Access Compliance Report

Public Rights-of-Way

(Curb Ramps)

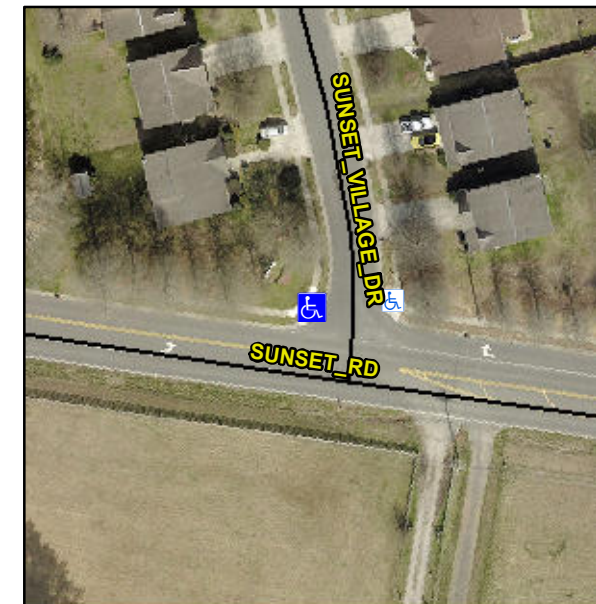
Intersection ID: 30073	Main Street: SUNSET_RD	Cross Street: SUNSET_VILLAGE_DR	Location: NW
ADA ID: 384F175EB223	Ramp Type: Perp	Initial Pass/Fail: Fail	Overall Compliance: No
Severity Score: 8.75			
Codes/Mitigation Info/Possible Solution		Field Measurements/Component Compliance

Not Found, R304.5.1

Compliance	Description	Data	Compliance	Description	Data
N/A	Ramp Length (in)	27.0	Yes	Ramp Slope (%)	7.0
No	Ramp Width (in)	45.0	Yes	Ramp XSlope (%)	1.4
N/A	Flare Type LT	N/A	N/A	Flare Type RT	N/A
N/A	Flare Slope LT (%)	N/A	N/A	Flare Slope RT (%)	N/A
N/A	Flare Traversable LT?	N/A	N/A	Flare Traversable RT?	N/A
N/A	Landing Length (in)	N/A	N/A	DWS Provided?	N/A
N/A	Landing Width (in)	N/A	N/A	DWS Contrast?	N/A
N/A	Landing Slope (%)	N/A	N/A	DWS Length (in)	N/A
N/A	Landing X Slope (%)	N/A	N/A	DWS Full Width?	N/A
N/A	Landing Curb? (Y/N)	N/A	N/A	DWS Offset (in)	N/A
N/A	Shared Landing?	N/A			
N/A	Gutter Ponding?	N/A	N/A	Gutter Slope (%)	N/A
N/A	Gutter Lip Ht (in)	N/A	N/A	Gutter X Slope (%)	N/A
N/A	Painted X Walk1?	No	N/A	Painted X Walk2?	N/A
	X Walk 1 Direction	To E		X Walk 2 Direction	N/A
N/A	X Walk 1 Width (in)	N/A	N/A	X Walk 2 Width (in)	N/A
	X Walk 1 Slope (%)	3.4		X Walk 2 Slope (%)	N/A
	X Walk 1 X Slope (%)	2.6		X Walk 2 X Slope (%)	N/A

Remove & Replace Entire Ramp.
